UNITED STATES PATENT AND TRADEMARK OFFICE

APPLICATION NO.	FILING DATE	FIRST NAMED INVENTOR	ATTORNEY DOCKET NO.	CONFIRMATION NO.
10/708,515	03/09/2004	Ronald L. Gordon	FIS920030380	2514
29505 7590 10/16/2007 LAW OFFICE OF DELIO & PETERSON, LLC. 121 WHITNEY AVENUE NEW HAVEN, CT 06510			EXAMINER RASHID, DAVID	
			ART UNIT 2624	PAPER NUMBER
			MAIL DATE 10/16/2007	DELIVERY MODE PAPER

Office Action Summary	Application No.	Applicant(s)	
	10/708,515	GORDON ET AL.	
	Examiner	Art Unit	
	David P. Rashid	2624

DETAILED ACTION

FIG. II

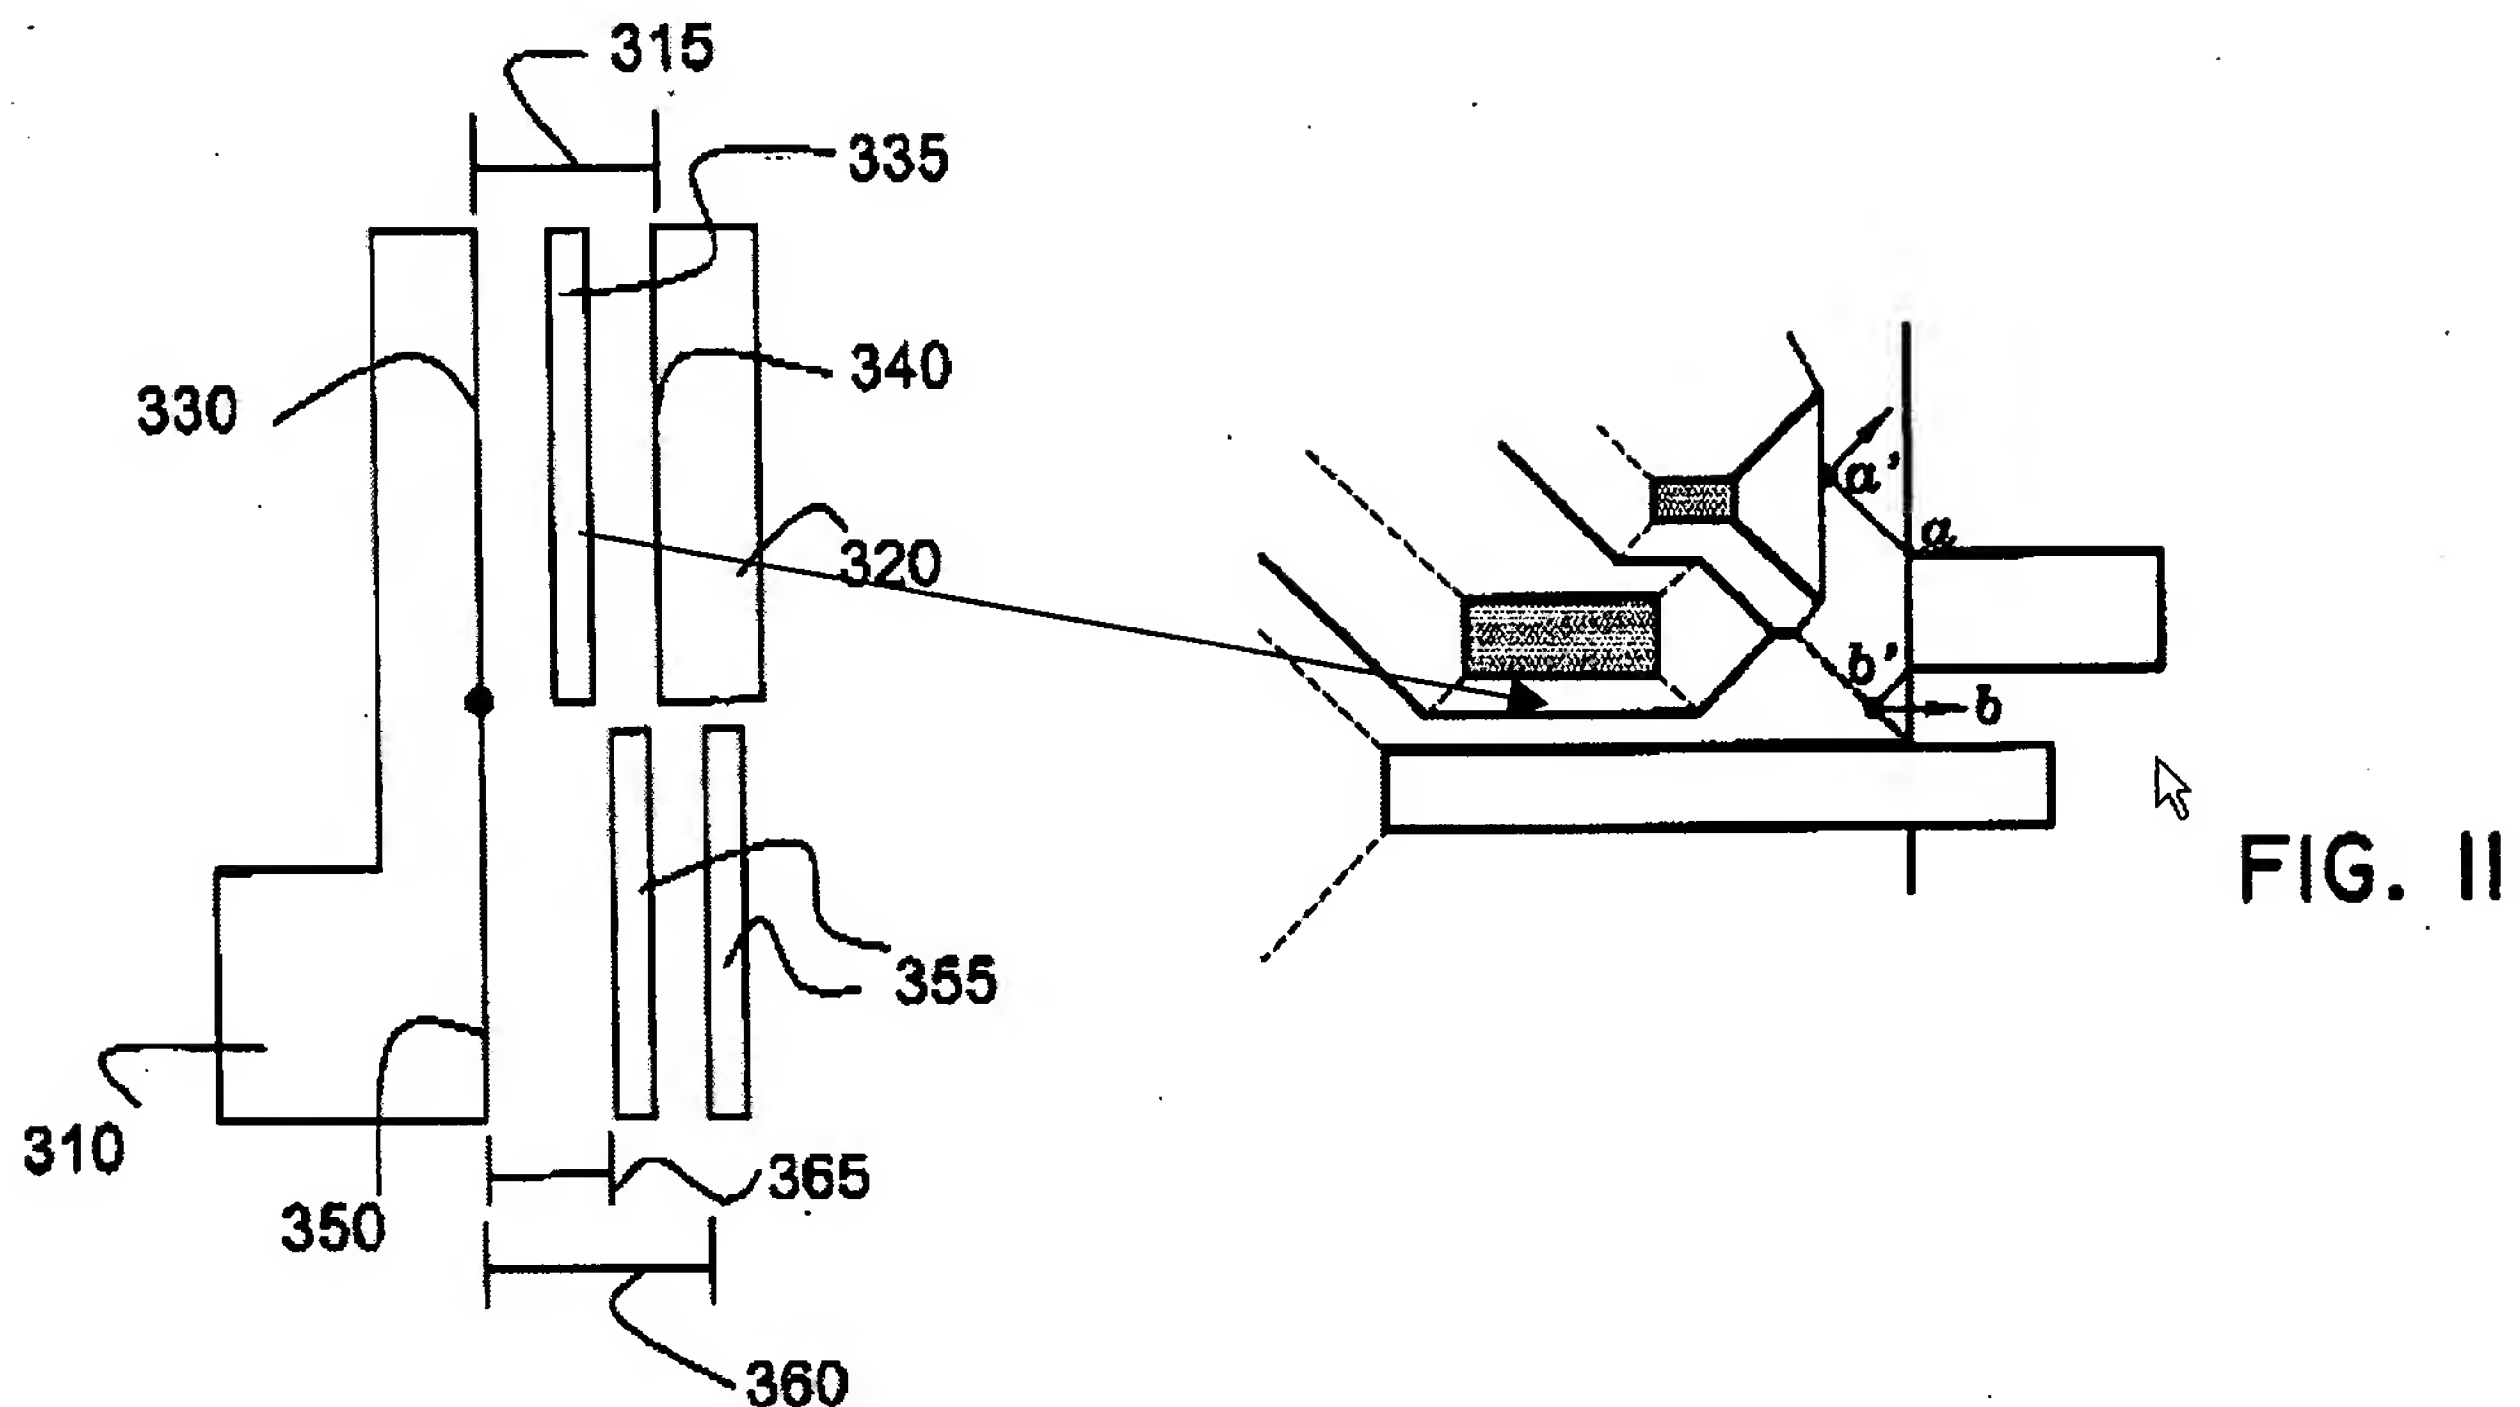
FIG. 11 of Papadopoulou (though FIG. 5 is equally applicable) provides fairly straightforward reasoning why it would have been obvious to one of ordinary skill in the art at the time the invention was made for the bisector and SRAF placement of Robles to use Voronoi cells and bisectors from the Voronoi algorithm of Papadopoulou. Robles in determining its bisector and SRAF placement could use the Voronoi algorithm of Papadopoulou to achieve the same results for any parallel partition between two edges as evident in FIG. 11 of Papadopoulou and FIG. 3 of Robles.

In such an instance of two parallel edges in Robles, the Voronoi algorithm of Papadopoulou would create the same bisectors for SRAF foundation of Robles, as it is only required that SRAFs are along “at least some of the bisectors between the adjacent ones”, and the

anticipation of Robles in view of Papadopoulou is whole (without the requirement that the bisector extends beyond the end of a feature edge that ends within the length of a parallel feature edge).
